American Hakko Products, Inc.

PRODUCT BULLETIN

Bulletin No: PB440
Issue Date: 9-3-2019
Effective Date: 10-1-2019

Description/Title:
T31-xxBC1 Shape Change

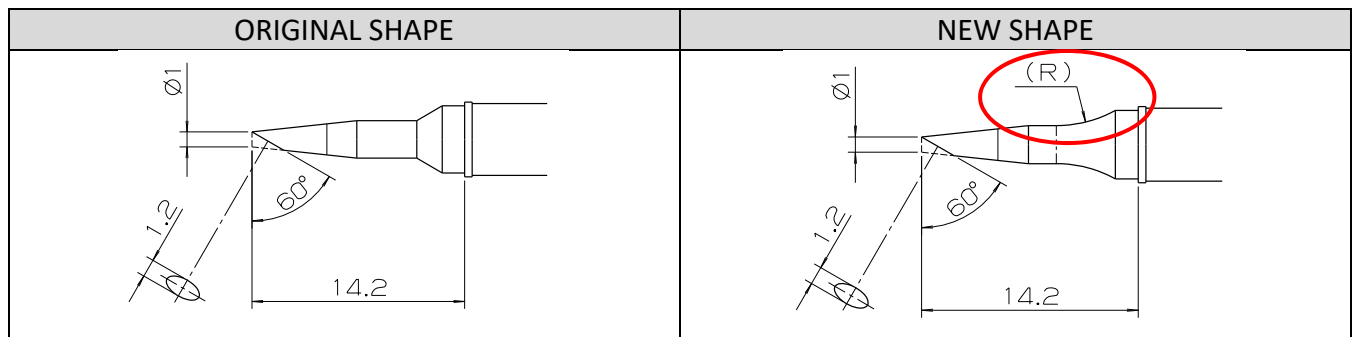
Hakko will be making a subtle change to the BC1 shape of T31 Series tips. This change (as shown in the diagram above) improves the heat transfer to the end of the tip by increasing the mass of the tip without affecting the reach and operator visibility.

This change will take effect 10-1-2019 or once remaining supply has been exhausted.
